Re: PA22-042 – Sunnyside Village Co-Housing – Technical Review 1

3121 66<sup>th</sup> Ave NE – APN: 29050300402100

PA22-042 Design Team Responses

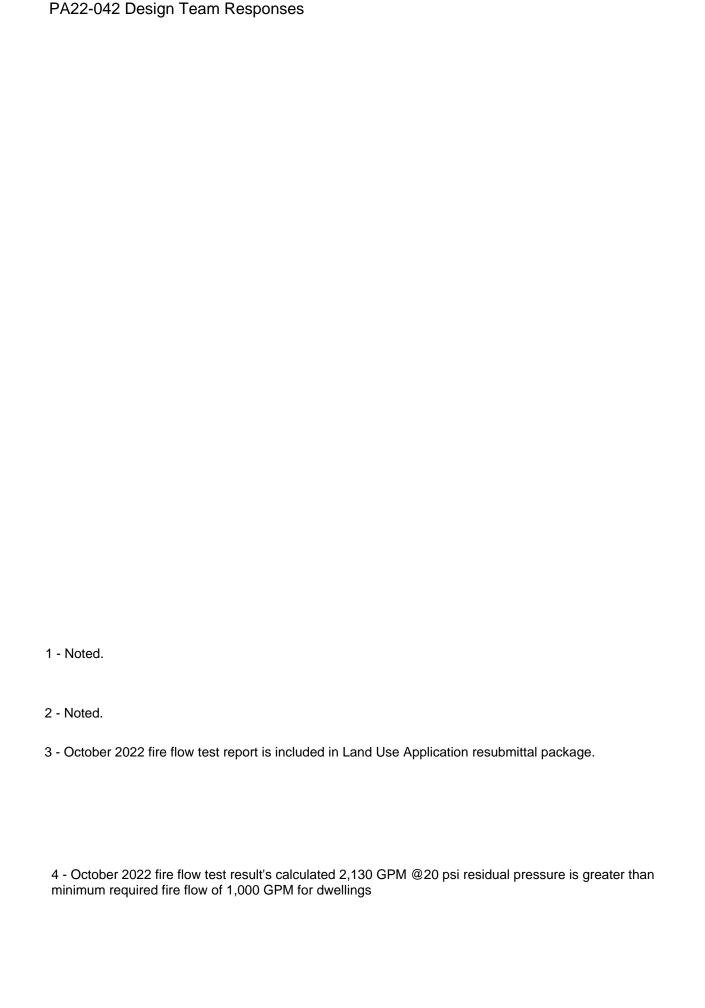
The plans show one fire apparatus access into the site from the north, and internally through the village, by a 22' wide private drive access road, a 360' long dead-end extension from existing 66<sup>th</sup> Ave NE. Plans show a fire access turnaround near the end of the private drive. Access for fire apparatus appears adequate.

The plans show water service for the project from the north by connection to existing 8" water main on 66<sup>th</sup> Ave. Plans also shown an 8" water main on the private drive. Plans show two hydrants being added, one approx. 70' north of private drive on 66<sup>th</sup> Ave. and one about 250' in on private drive. Hydrant spacing appears adequate.

The City GIS water map shows an existing 8" water main dead-ends near the north property line along 66<sup>th</sup> Ave NE, with a fire hydrant located about 150' north of the property line, and an existing 12" water main along Sunnyside Blvd. No information about available fire flow is provided for nearby fire hydrants. *An adequate water supply for fire flow shall be provided*.

- 6 Water main is designed to loop through 66th Ave NE.
- 7 Civil drawings are citing City standard plans.
- 8 Contractor has been informed of this construction sequencing requirement.
- 9 All buildings are being designed with sprinkler systems, for compliance with exception 1.

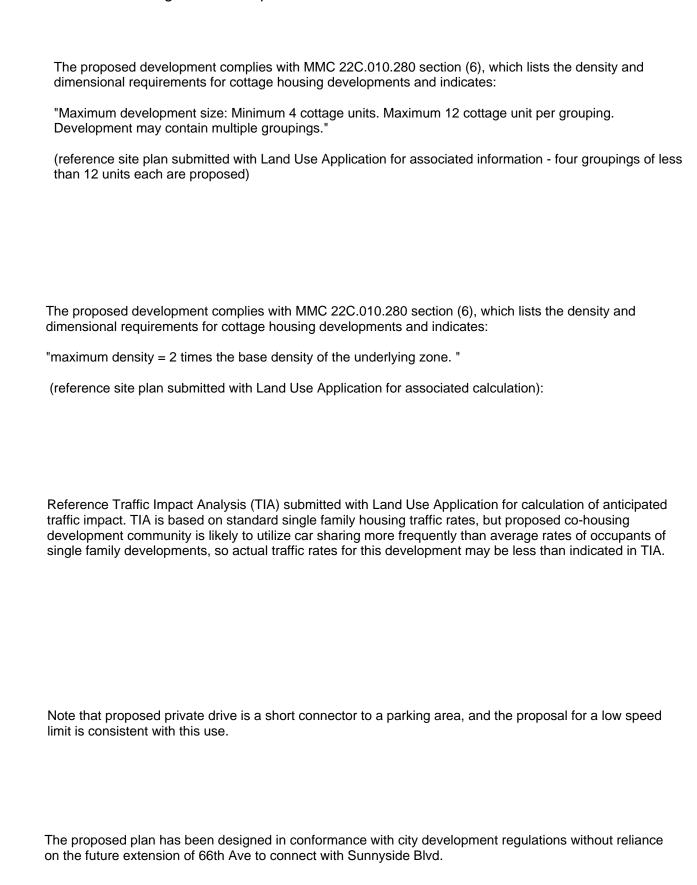
- (1) The conditional use is designed in a manner which is compatible with the character and appearance of the existing or proposed development in the vicinity of the subject property
- a. Response: While each cottage is smaller than typical adjacent single family residential homes, the design is compatible with adjacent neighborhood character and appearance in terms of roof profiles, exterior siding types, window and door types, porches, and bay windows.

The response fails to address that the cottages are not just smaller, but half of the square footage of the adjacent neighborhood while being at twice the structure density of the adjacent neighborhood. The dense layout of the houses and existence of separate parking lots is nothing similar to the well-established neighborhood the proposal refers to. There are no apartment buildings or similarly sized houses in the near vicinity and current in-work construction in the surrounding areas of Marysville do not resemble the proposal. Nowhere on Sunnyside Blvd from 52<sup>nd</sup> St NE to Soper Hill Rd are there such high density housing or implied "compatible" developments.

## PA22-042 Design Team Responses As described in the design team response on the previous page, the proposed development complies with the density and dimensional requirements of MMC 22C.010.280 section (6). This section allows a maximum of 12 units per grouping and multiple groupings per development, and a maximum density of 2x the density of the underlying zone. While home sales and property values are not a land-use issue, there is sufficient evidence (through home sales data) to demonstrate that co-housing homes maintain their value and in some cases exceed the market rate value of nearby homes. Furthermore, developers of speculatively built homes (like in the adjacent subdivision) did not have to demonstrate that they had all their homes spoken for before their permits were approved. MMC 22C.010.280 section 2(d) allows for cottage housing developments on single family zoned parcels meeting certain criteria, and not just in medium and high density zoned areas.
